Monthly Specification Update

Intel® Server Board S5520UR

Intel Order Number E69054-001

Dec 2011

Figure 1. Removing the Heatsink

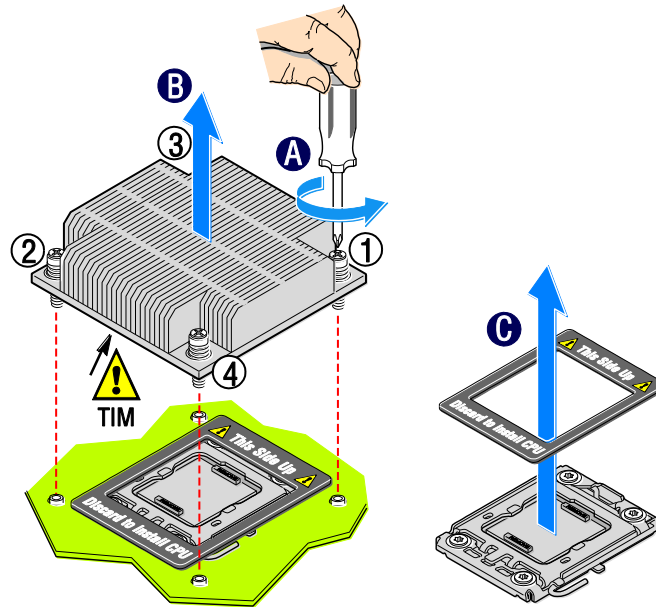
1. Proper Heatsink Installation and Removal Instructions are missing from Service Guide

Problem: The current documentation does not properly describe the installation and removal of the heatsink. Careful insertion and removal of the heatsink is required to prevent damage to the heatsink screws or backplate.

1. Loosen the four captive screws on the heatsink corners in a diagonal manner according to the numbers shown in figure 1 as follows:
 - Starting with the screw at location 1, loosen it by giving it **two rotations** in the anticlockwise direction and stop. (**IMPORTANT:** Do not fully loosen.)
 - Proceed to the screw at location 2 and loosen it by giving it two rotations and stop.
 - Loosen screws at locations 3 and 4 by giving each screw two rotations and then stop.
 - Repeat steps 1a through 1c by giving each screw two rotations each time until all screws are loosened.
2. Do one of the following:
 - If removing the heatsink for the first time, do the following:
 - i. Lift the heatsink from the board.
 - ii. Remove and discard the spacer (see letter “C” in figure 1).
